Re: Exhibition MP 09 0162 of 14-18 Boondah Road, Warriewood

Re: Exhibition MP 09_0162 of 14-18 Boondah Road, Warriewood

We refer to the exhibition of the Concept Plan and Stage 1 Precinct Plan proposing the residential development for apartment buildings of 3 and 5 storeys on land known as 14-18 Boondah Road, Warriewood.

Figure 1: Typical Sub-Arterial road reserve treatment – Warriewood Valley Roads Masterplan 2006.

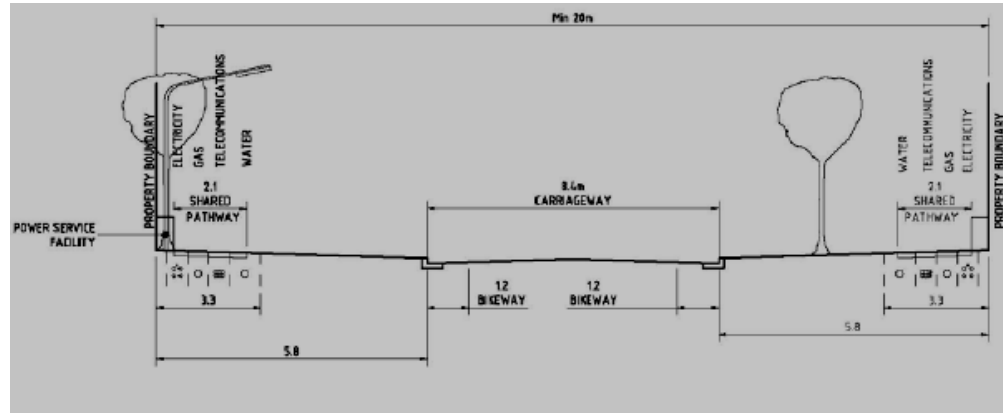
Under the Warriewood Valley Roads Masterplan, 2006. Boondah Road is identified as a sub-arterial road. This plan requires a sub-arterial road to be provided within a minimum road reservation width of 20.0m, as detailed in Figure 1.

In conjunction with the road reserve width of 20.0m, a 6.5m setback applies to Boondah Road under Pittwater 21 DCP. The suggested re-aligned road would achieve a physical separation between residential buildings and future non-urban development of 33.0m (20.0m + 6.5m + 6.5m).

Conceptual Re-alignment of Boondah Road.

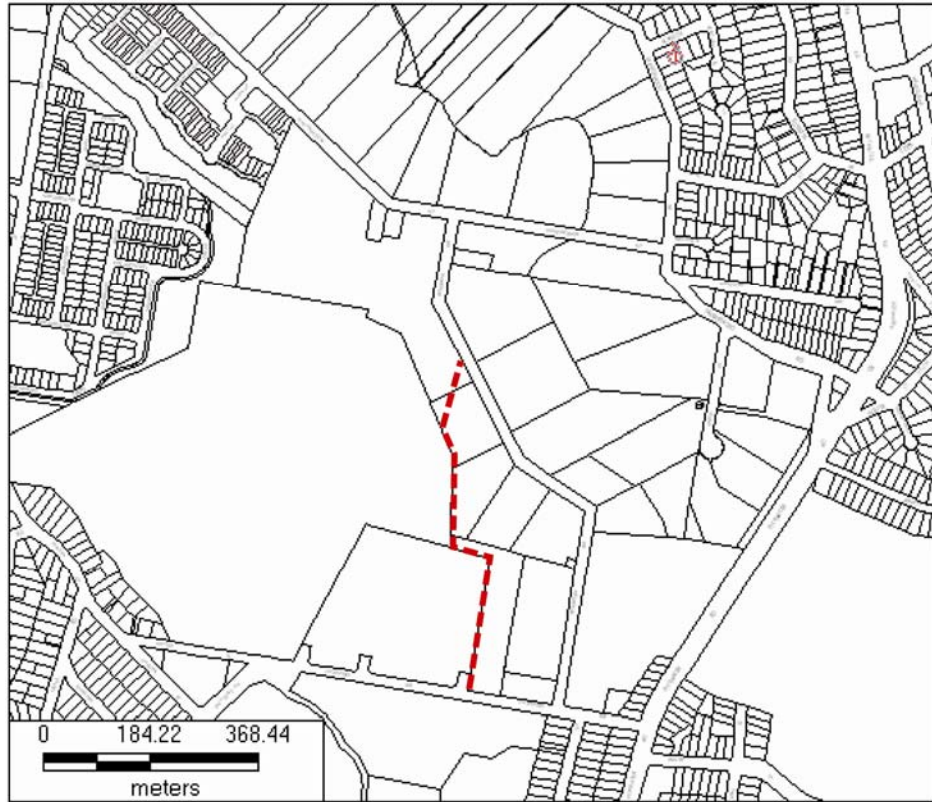
The current development proposal represents a final opportunity to implement and pursue the re-alignment of Boondah Road that is contemplated within the suite of guidelines for development in Warriewood Valley, titled "Landscape Masterplan and Design Guidelines (Public Domain)", dated October 2007.

A realignment of Boondah Road in the manner contemplated by the landscape Masterplan would impact upon the configuration of the most southerly portion of 14-18 Boondah Road and the layout of a future development of No.s 10 and 12 Boondah Road and No.6 Jacksons Road. A conceptual alignment is included in Attachment 2. Such a re-alignment would also deliver the advantage of a physical separation of the land uses and largely remove the need for the buffers discussed above. A re-alignment that affects 14-18 Boondah and 12 Boondah Road would also accommodate the retention of a stand of angophora trees located near the boundary between the two properties.
